## Staff Report to the Board of Architectural Review Pacific Northwest Regional Council of Carpenters Headquarters

Prepared September 15, 2020

<b>Hearing Date:</b>	August 27, 2020
<b>File Number:</b>	L20-0023 Design Review
<b>Associated Permits:</b>	E20-0003 SEPA Decision L20-0006 Lot Consolidation
<b>Applicant:</b>	PNWRCC (Tom Rieger)
<b>Request:</b>	Construct a three-story, 36,600 square feet office building with a rooftop patio. The project will be completed with a new parking lot, site lighting, storm drainage, frontage improvements and landscaping.
<b>Location:</b>	5119 S 151 <sup>st</sup> ST, 15102 51 <sup>st</sup> Ave S Parcel #s 9844400035, 9844400045
<b>Comp Plan and Zoning Designation:</b>	Office (O)
<b>Environmental Review:</b>	Determination of Non-Significance provided August 4, 2020.
<b>Public Notice:</b>	Notice of Application was posted on site and mailed to surrounding property owners, tenants, and agencies with jurisdiction on March 18, 2020. Notice of BAR public hearing was posted onsite and mailed to property owners and tenants within 500 feet of the property and agencies with jurisdiction on September 10, 2020.

**Fig. 9: Site circulation patterns; vehicle access point in red, pedestrian access in blue.**

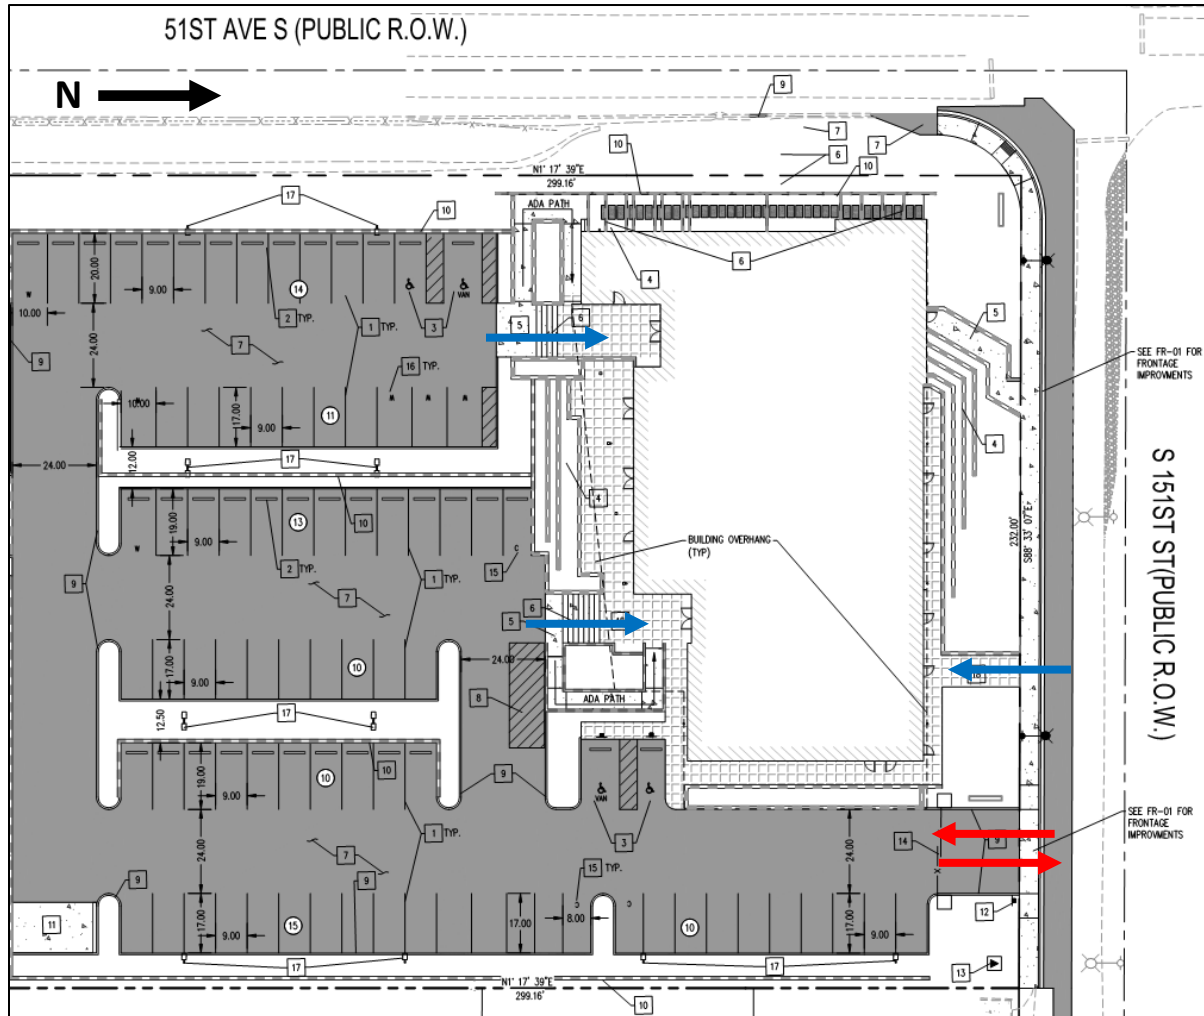
**Fire Department, 9.3.2020:** *Fire Department will need access to/from west side of site via stairs/ramp from 51st AVE S. Fire Department vehicle access is required to be within 150' of any portion of an exterior wall of the first story. It appears that there is no direct access via the stairs located on the Westside of the property, adjacent to 51st AVE S. The required access is not provided from either street.*

**Applicant Response, 9.10.2020:** As reviewed with the City on 9/1/2020, the site is challenging due to its slope. Two options were discussed in the meeting and we are pursuing both. Option 1 will provide for fire apparatus turnaround as previously provided with our autoturn exhibit. We will add to our architectural site plan a stairway to access the upper parking level which will satisfy the 150' reach range. Option 2 shall provide stairway access from 51st street without crossing the property line.

*Fig. 11: Proposed trash enclosure Shou Sugi treatment and location (blue outline). 10' of perimeter landscaping and an adjacent landscape island provide additional screening.*

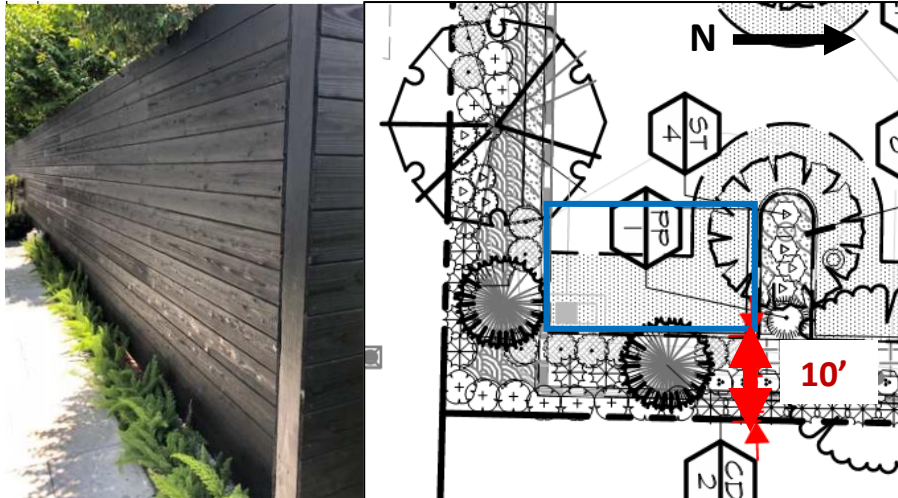
2. *Waste enclosure should be relocated from the southeast corner to the southwest site corner or adjacent to the south east portion of the courtyard on the south side of the applicant's proposed building, away from residences. Concerns for offsite impacts of waste enclosure (appearance, smell, noise, etc.).*

Applicant coordinated with Waste Management to locate refuse enclosure onsite. It was found that, due to significant sloping from west to east on the site, locating the enclosure at the site's southwest corner would involve a significant grade for waste trucks to navigate and make entering/exiting the site more difficult. Locating the enclosure closer to the building, as suggested, would create potential fire lane access conflicts in the case of an emergency response. Thus, the southeast corner was deemed safest. Waste units are to be enclosed and designed to match overall project concept during design review per City code. Additionally, the project is expected to primarily generate waste that is incidental to an office operation, i.e. non-organic material, reducing the potential for disturbance from animals. Enclosure, waste units, and adjacent landscaping will be required to be maintained for life of project per City code.

The City concurs with the applicant's proposed waste enclosure location.

*Fig. 13: Lighting Plan. P1 fixtures to be equipped with shields to reduce spillover on adjacent properties.*

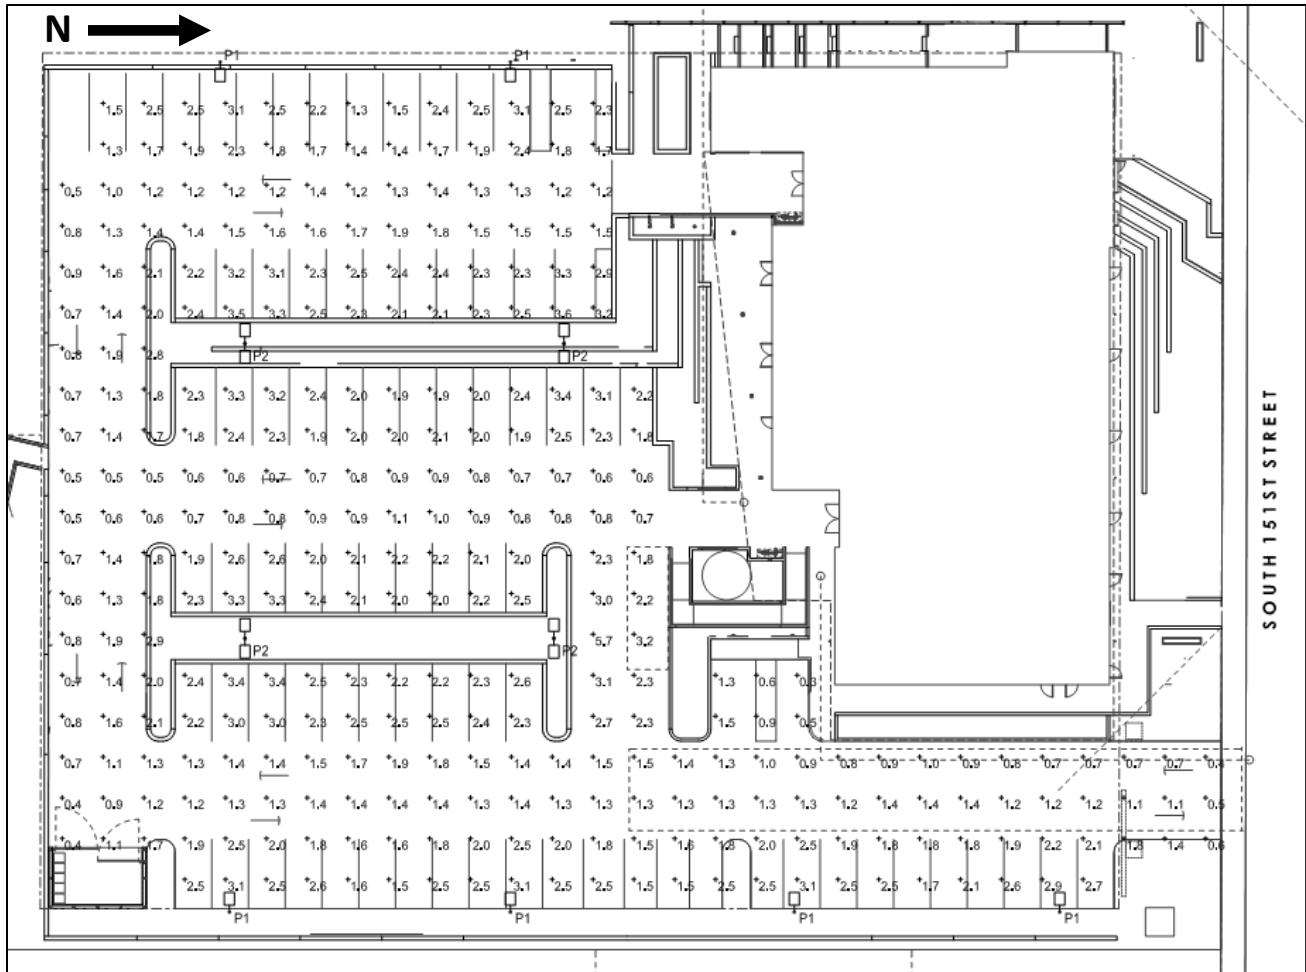
4. *Lighting should be focused on the proposed development and shields utilized to minimize light pollution in the adjacent residential homes.*

The applicant has provided an updated plan set showing that site light poles will be reduced to 15' in height and lights along the edge of the property will be provided with house side shields. The photometrics have been updated to show a reduced light level along the east property line. When the lights are reduced to 50% output at night (when no occupancy is detected) the light levels along the west property line will be .4 or lower.
